**PROPOSAL**  
**to ESTABLISH CLASS C at LGB and**  
**REVISE the SNA CLASS C**

FR Doc. 2010-7652

## Sector B

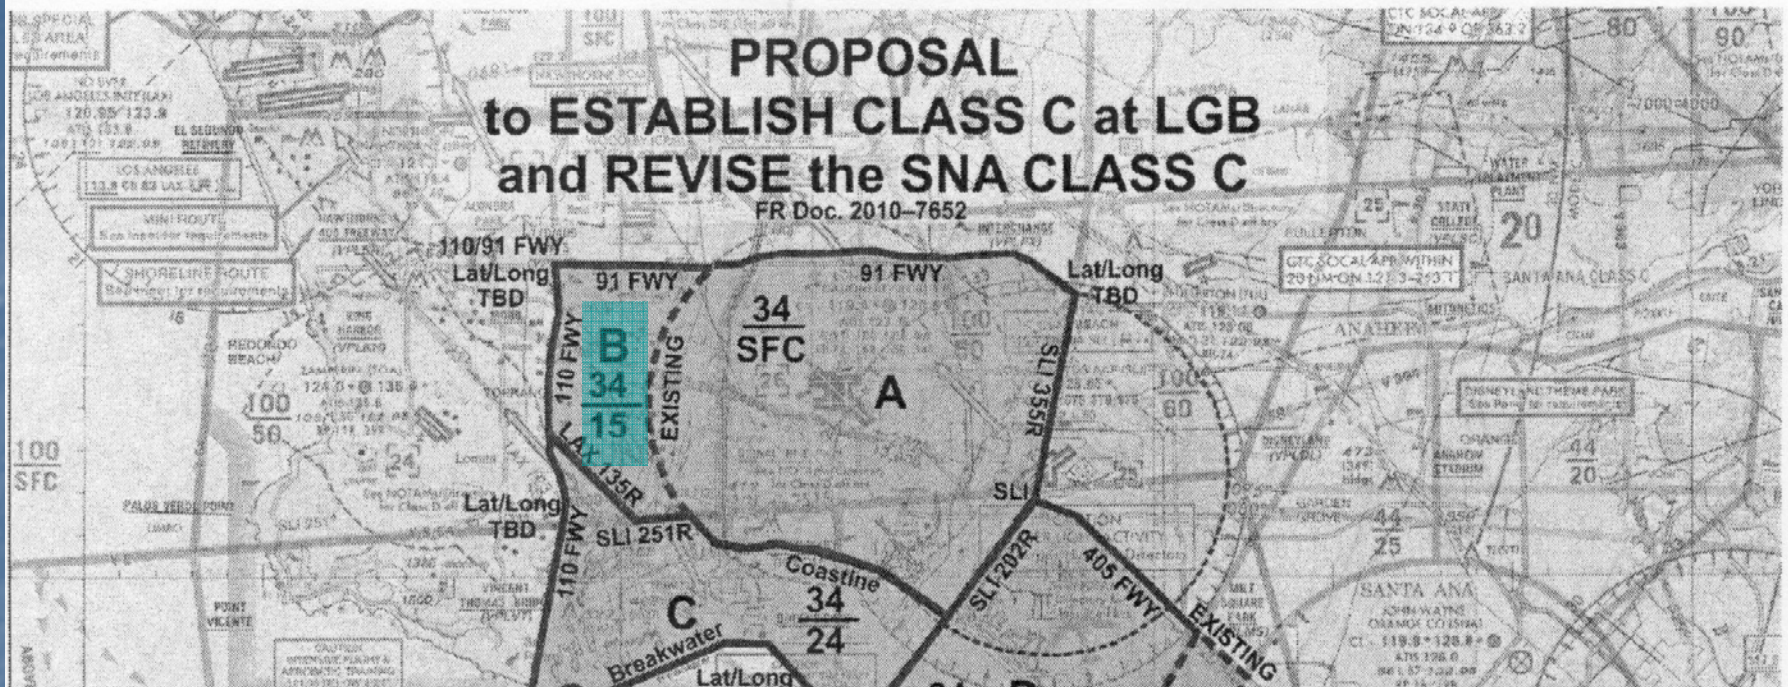
1. Underlies Class B LAX, compression between 3400 and 5000 feet
2. LAX 135 radial mislabeled, 120 radial may be more accurate.
3. Boundaries combine landmarks, radials, radial intersections and imaginary curves.
4. VFR flyway “at or below 2500” obsolete.
5. VFR traffic held to below 1500; compression of traffic between 1100 ft (1000 ft over congested areas) to 1200 ft (safety buffer, 300 ft below floor). Affects traffic shoreline to Compton, Hawthorne, El Monte.

## Sector C

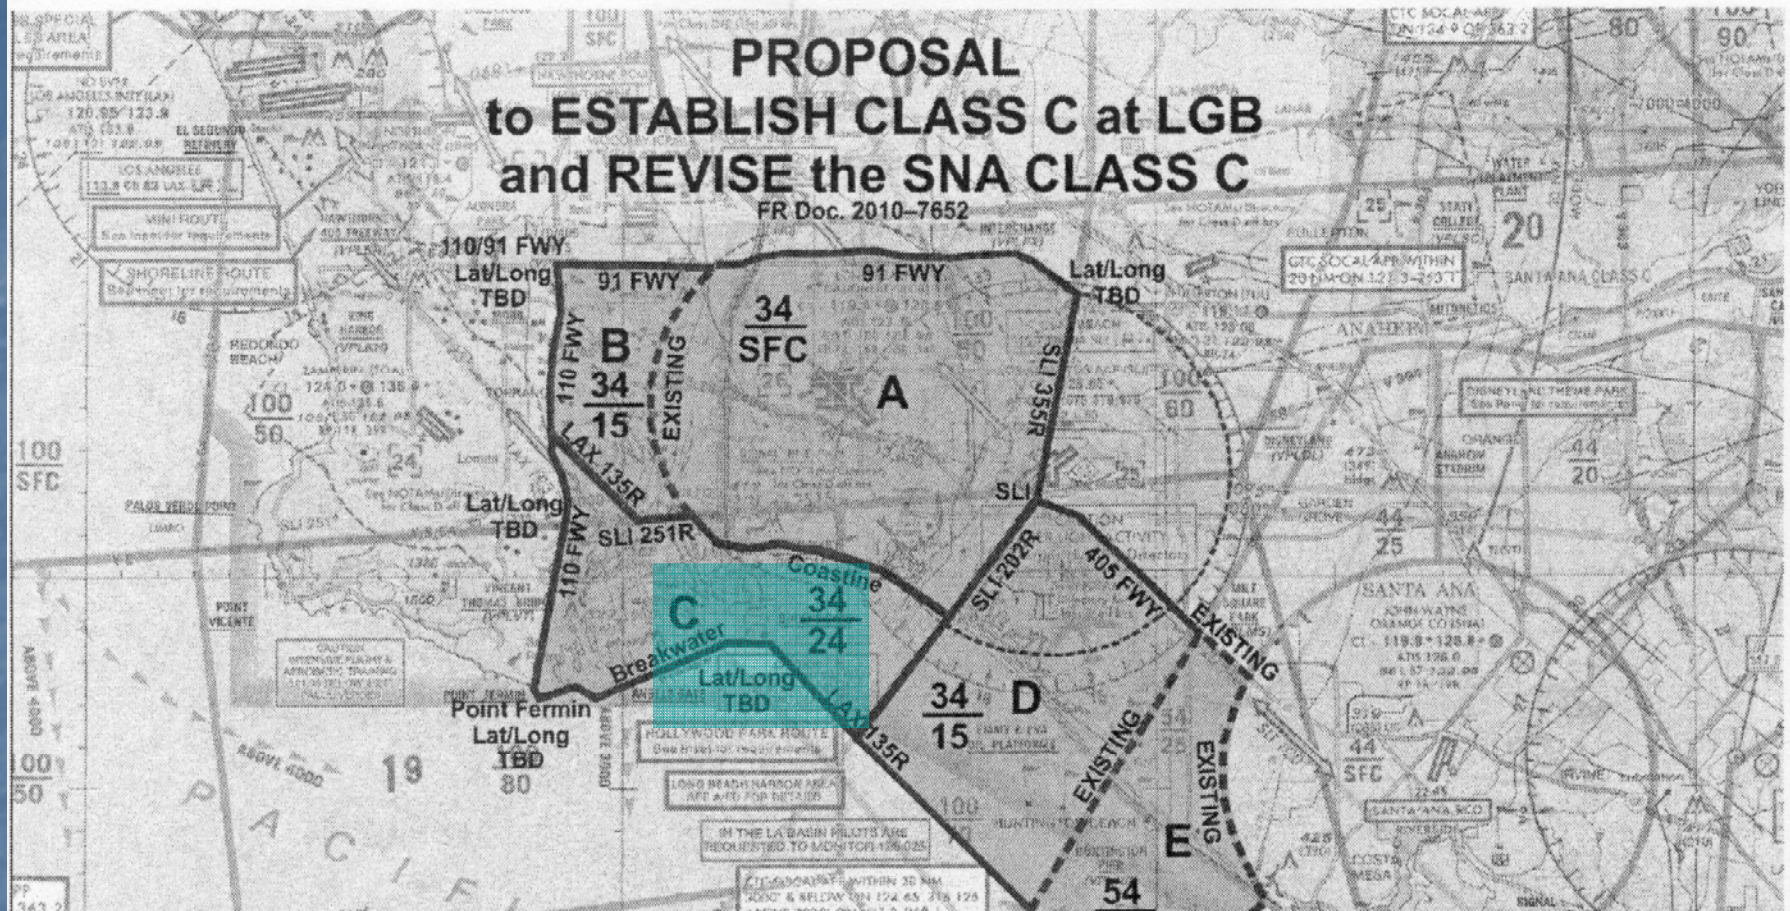
1. Underlies Class B LAX, compression between 3400 and 5000 feet
2. Doesn't buffer air carrier traffic with 500 feet vertical separation unless at 2900 ft. Non participating VFR traffic potentially at 2399 ft.
3. Boundaries combine landmarks, radials, radial intersections and imaginary curves.

## Sector D

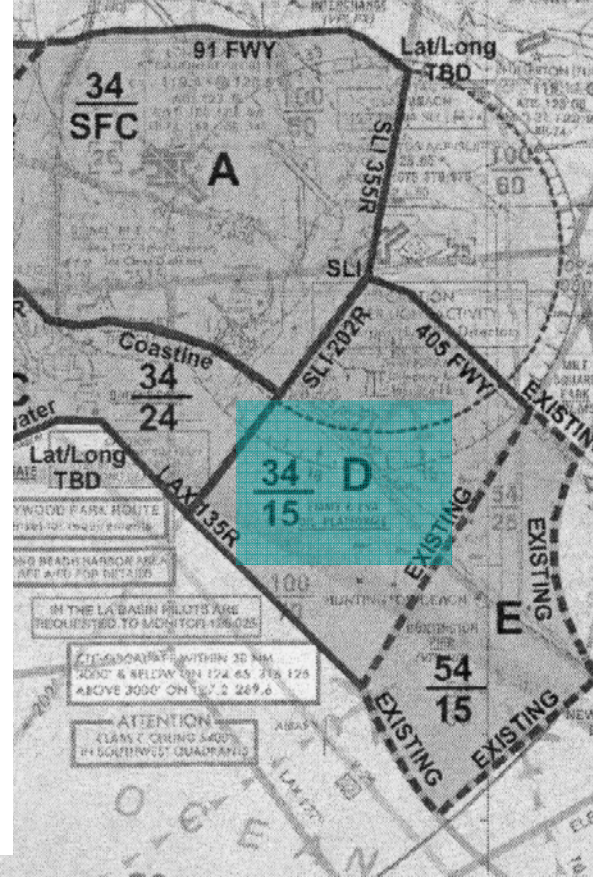
1. Underlies Class B LAX, compression between 3400 and 7000 ft.
2. Takes 1/4 of Los Alamitos AAF airspace between 1500 ft and 2500 ft.
3. Boundaries combine landmarks, radials, and radial intersections.

4. VFR traffic held to below 1500; compression of traffic between 1100 ft (1000 ft over congested areas) to 1200 ft (safety buffer, 300 ft below floor). Affects traffic shoreline to Fullerton and other inland destinations.

**Sector E**

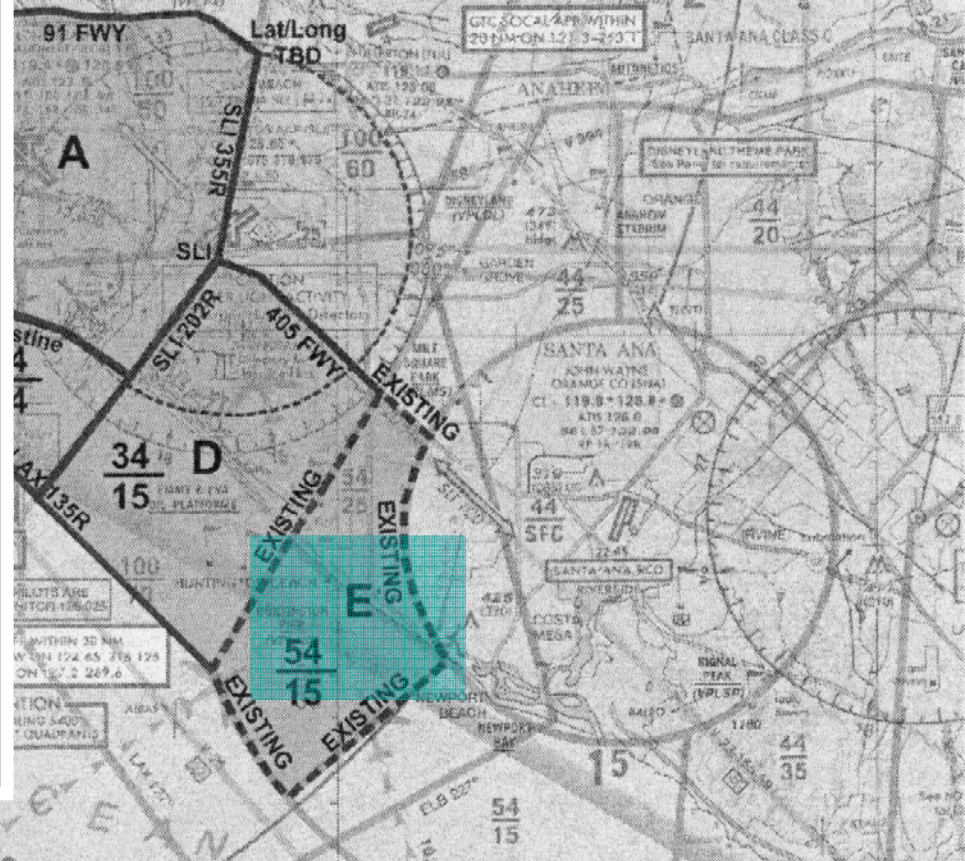
- 1. Underlies Class B LAX, compression between 3400 and 7000 ft**
- 2. “Existing” along southeast boundary is misleading; base has been lowered from 2500 ft and 3500 ft to 1500 ft.**
- 3. Boundaries combine landmarks, radials, radial intersections and imaginary curves.**

## LGB DEPARTURES

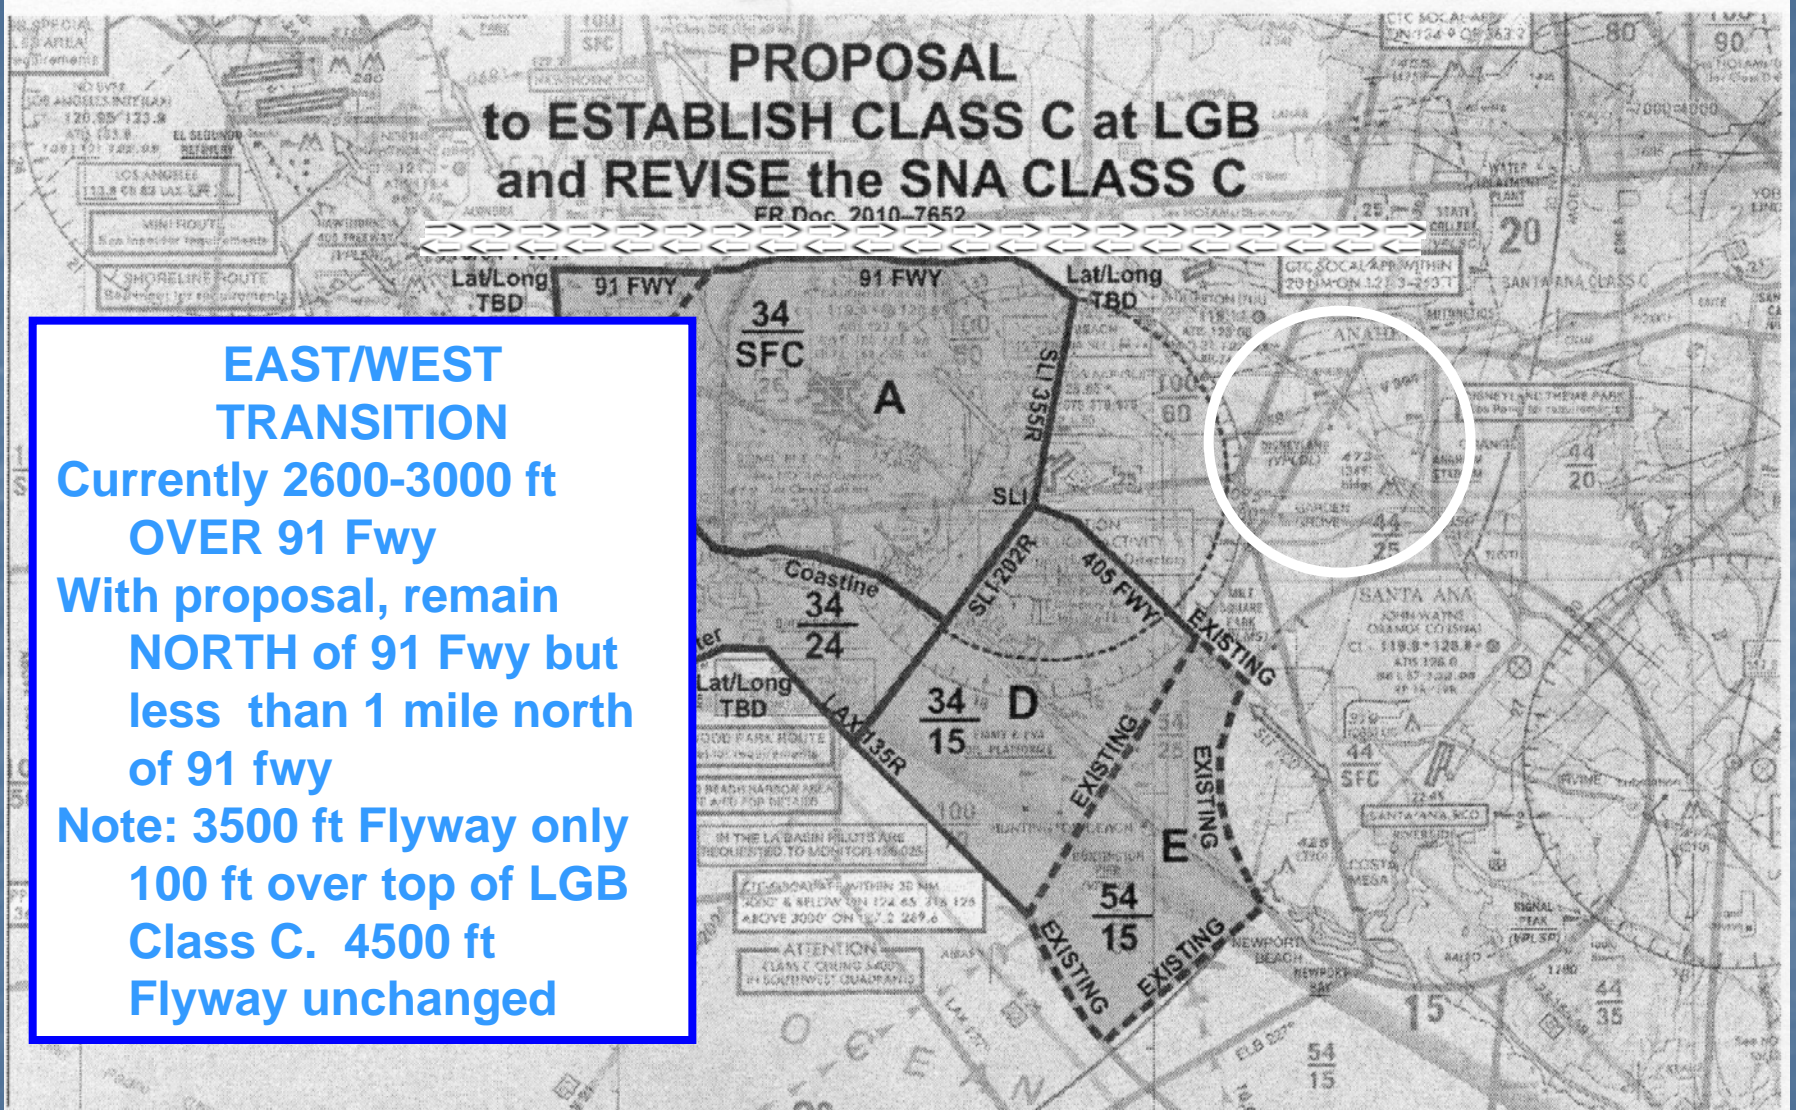
Participating aircraft held  
at or below 3400 would  
exit Class C in VFR  
practice area

Notam on ATIS or within  
clearance that  
departure may not be  
contained within Class  
C?

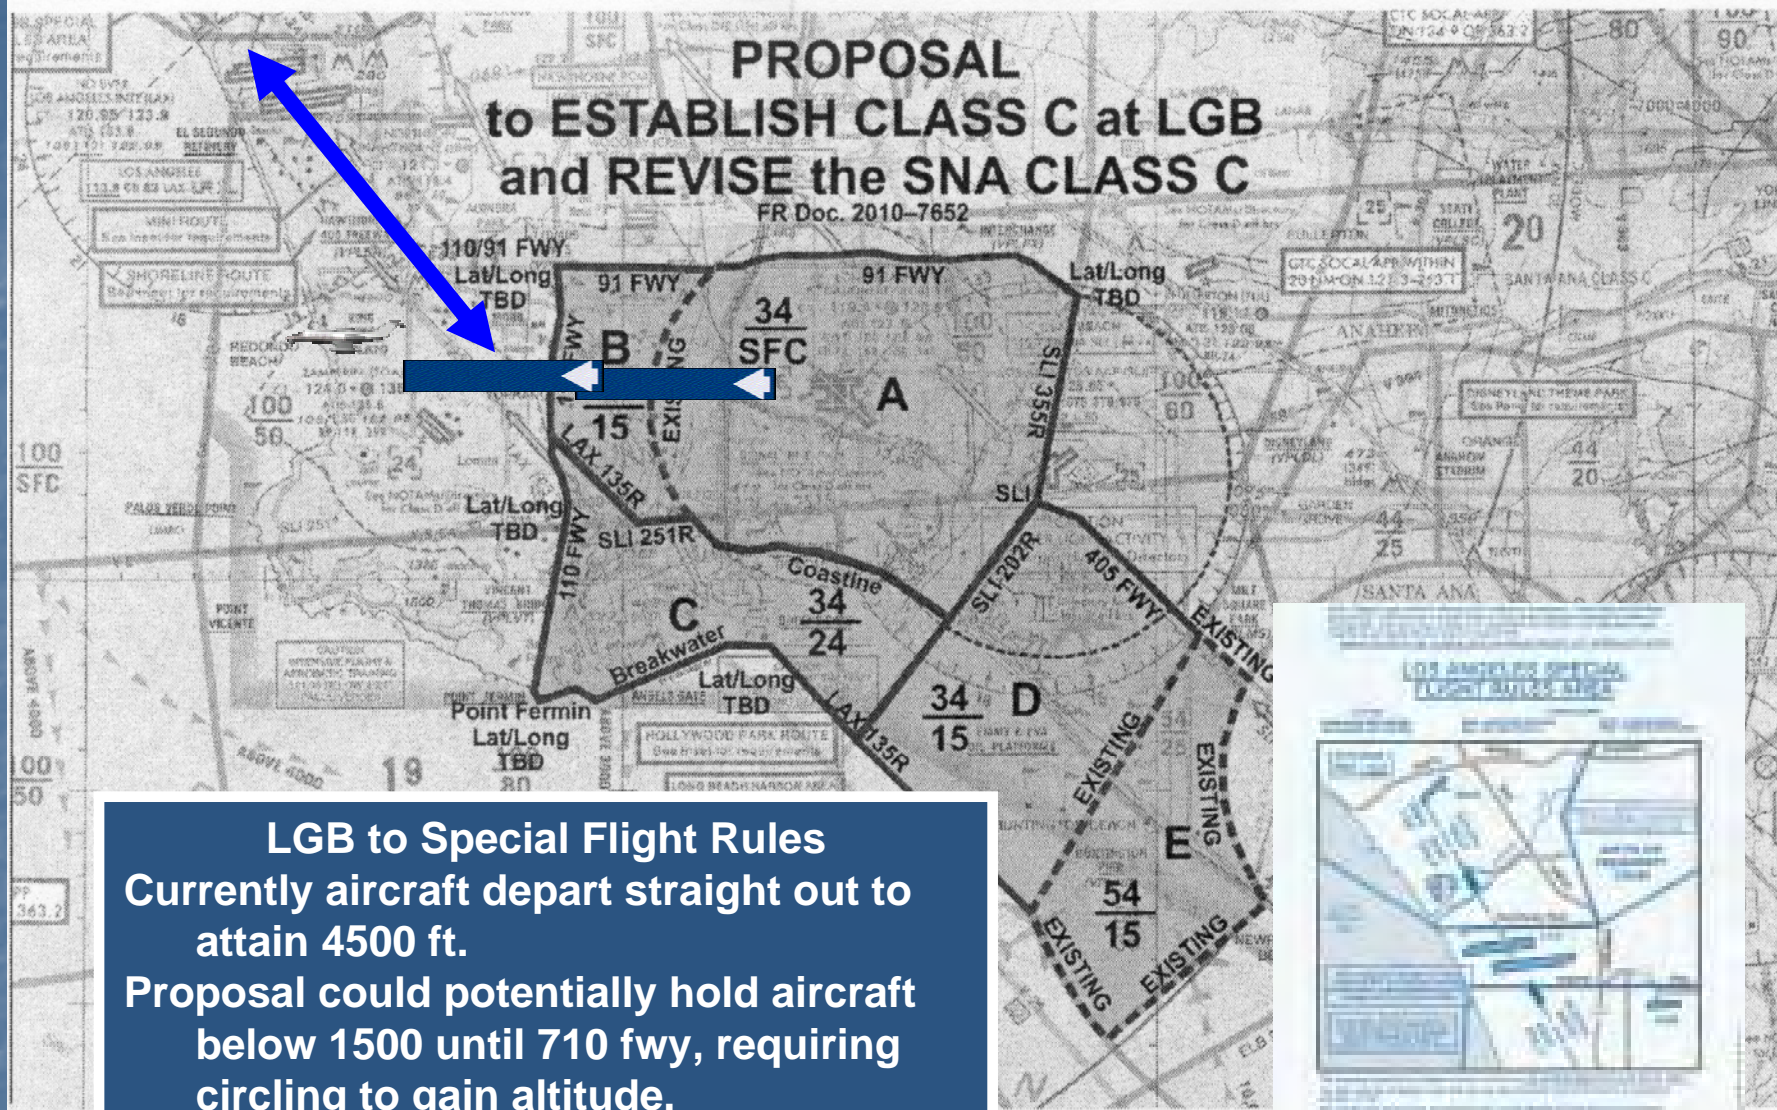
**LGB to Special Flight Rules**  
Currently aircraft depart straight out to attain 4500 ft.  
Proposal could potentially hold aircraft below 1500 until 710 fwy, requiring circling to gain altitude.
